ZTE CORPORATION

Product Change Description

[Project Number:17ZTE191-01]

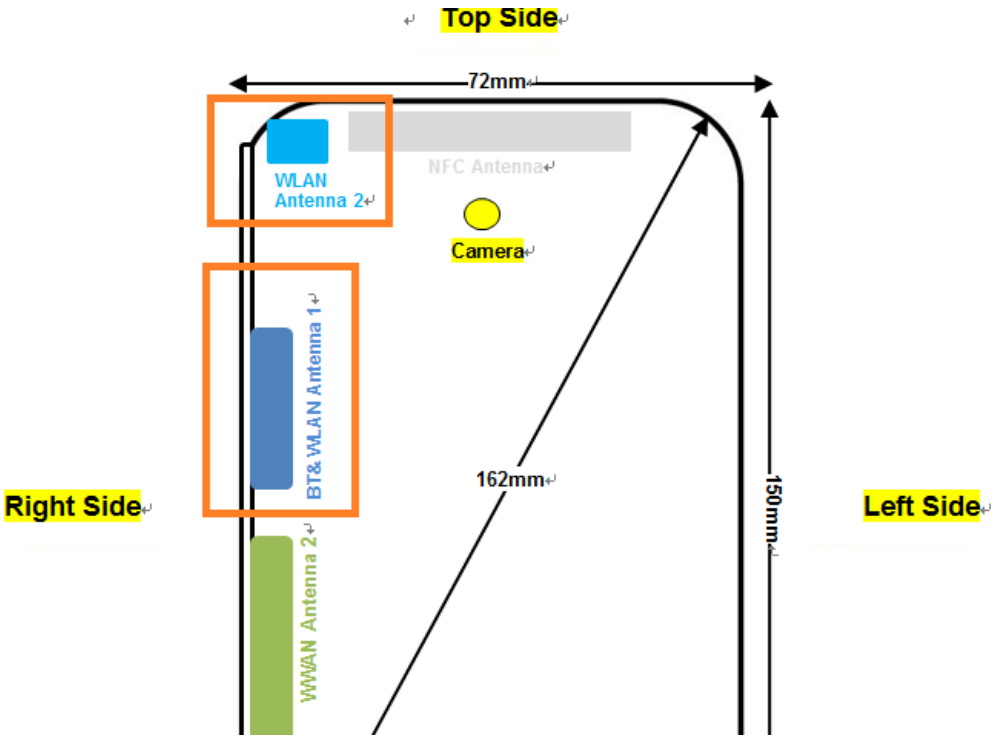
Protocol Stack changes: NO
MMS/STK changes: NO
JAVA changes: NO
Other changes detailed: Yes, ZTE now switch WLAN Antenna 1 and 2's function. This means WLAN Antenna 2 in below picture now support Bluetooth and WIFI while WLAN antenna 1 only supports WIFI MIMO function.
